<b>Title of Change:</b>	Lead Frame Design change for PDIP7 Products Assembled in Advanced Semiconductor Engineering (ASE) Kunshan, China.
<b>Proposed first ship date:</b>	18 August 2017 or earlier after customer approval.
<b>Contact information:</b>	Contact your local ON Semiconductor Sales Office or <marty.paul@onsemi.com>
<b>Samples:</b>	Contact your local ON Semiconductor Sales Office
<b>Additional Reliability Data:</b>	Contact your local ON Semiconductor Sales Office or <Andy.Esteva@onsemi.com>
<b>Type of notification:</b>	This is a Final Product/Process Change Notification (FPCN) sent to customers. FPCNs are issued 90 days prior to implementation of the change. ON Semiconductor will consider this change accepted, unless an inquiry is made in writing within 30 days of delivery of this notice. To do so, contact <PCN.Support@onsemi.com>.
<b>Change Part Identification:</b>	Affected products will be identified with date code 1733 or newer. After DC 1733, customers will receive products assembled with either lead frame design.

This FPCN is to notify customers that qualification has been completed for a new Lead Frame form on PDIP7 packages assembled at the ASE, Kunshan, China assem

Figure 1 - External End View

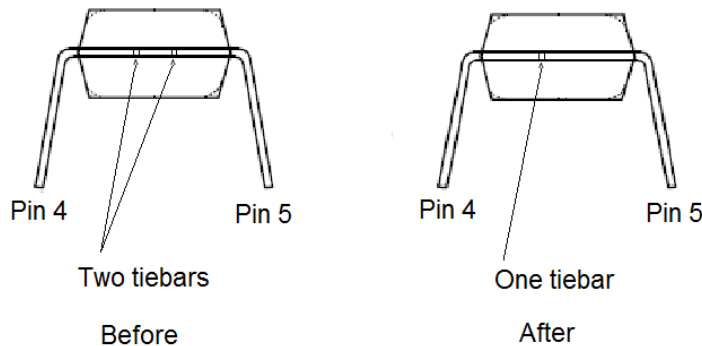
Material to be changed	Before Change	After Change
	Description	Description
Leadframe	PDIP7 Lead frame with 4 tie bars	PDIP7 Lead frame with 3 tie bars

The form of the Lead Frame has been modified to improve creepage distance between tie bars, see figure 1. One tie bar has been removed.
